Staff Report

Downtown Design Review

File Number: 11-D-25-DT

Project: City Summit

P22 SOUTH ELEVATION B
1/8" = 1'-0"

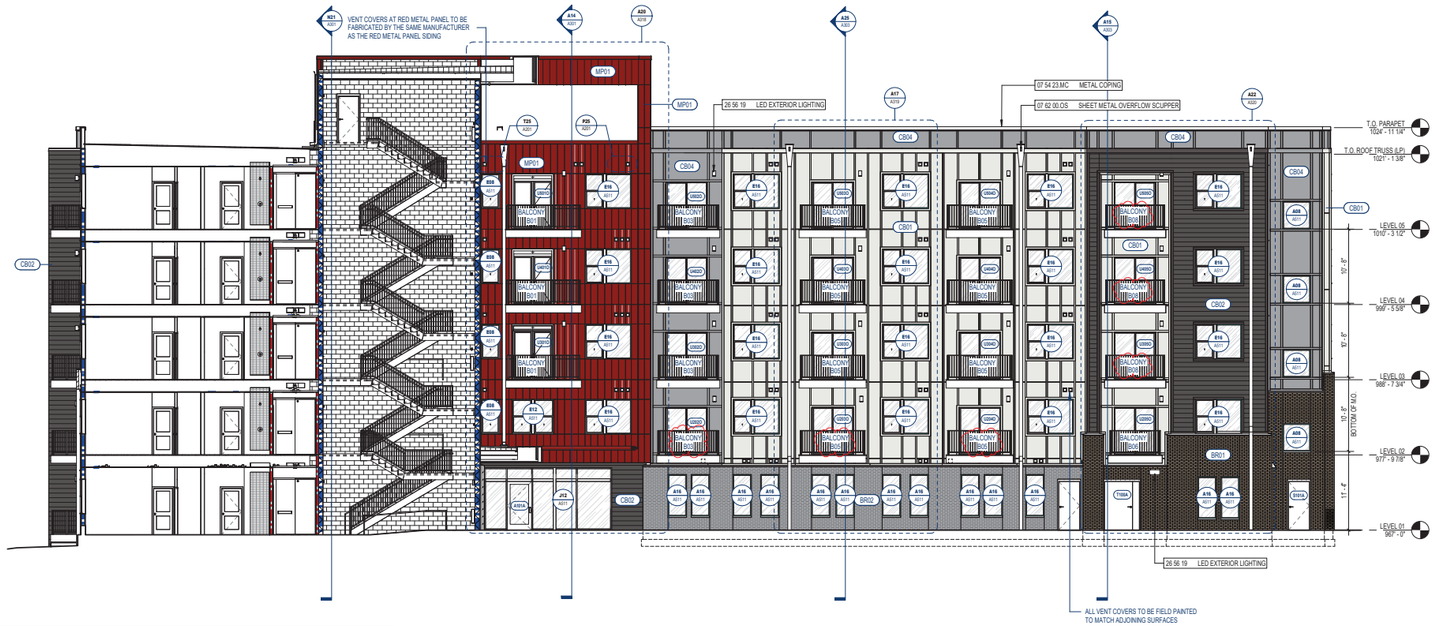
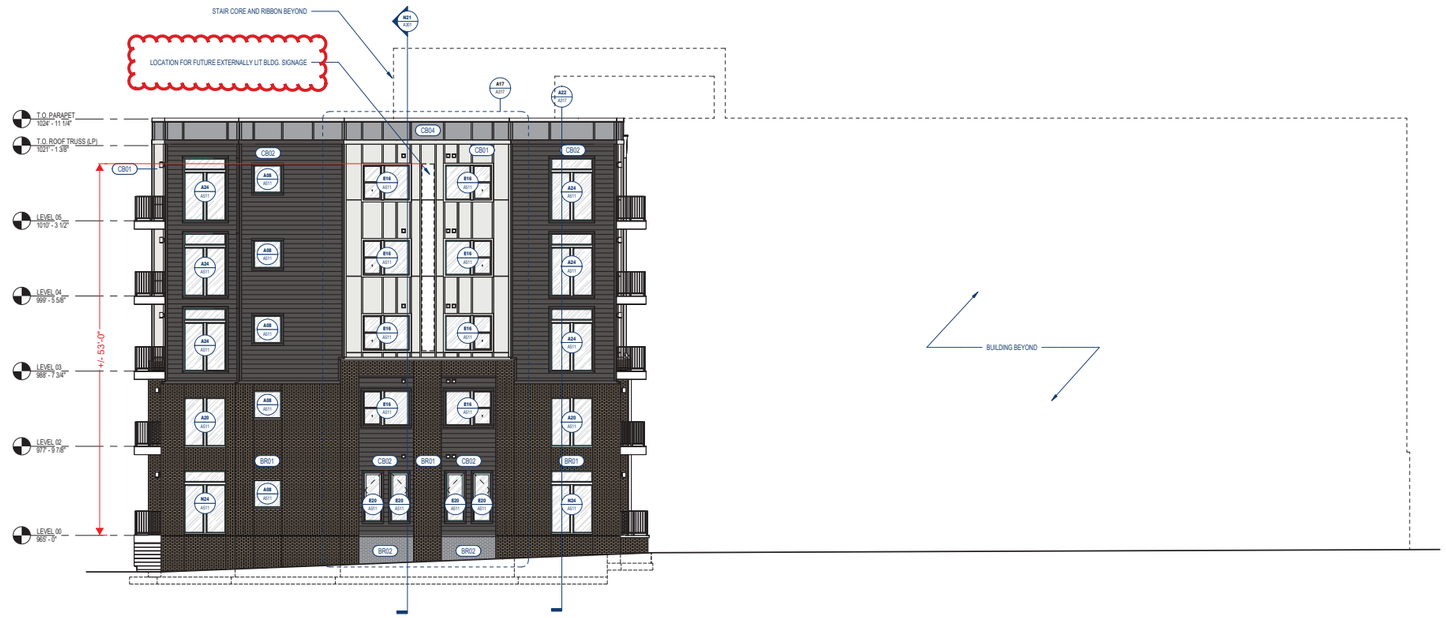
Installation of two identical non-illuminated channel letter wall signs, each measuring 2' wide by 26' tall (52 sq ft). The black channel letters with 1.5" returns will be mounted on the fiber cement boards with 3/8" toggle anchors, without a raceway. One sign will be placed on the south elevation, facing Cafego Place, and the other will be placed on the east elevation, facing the site's parking lot. The top of the signs will align with the top of the fifth-story windows, and will be approximately 25' above ground level.

The Design Review Board approved certificate 4-E-24-DT for the construction of a five-story multifamily development on the subject parcel. One of the conditions of approval was that signage must be submitted to the Board as a separate application. The proposed signs reflect the recommended types for the Boulevard district, and the scale and location of the proposed sign are compatible with the height of the building. The plans note that the signs will be externally lit; however, the applicant has stated that these will be non-illuminated.

Staff recommends approval of Certificate 11-D-25-DT, subject to the following conditions:
1) The signs shall be placed centrally on the fiber cement board, maintaining an equal distance from windows on both sides.

2) Any future external lighting for these signs must be reviewed and approved by Planning staff.
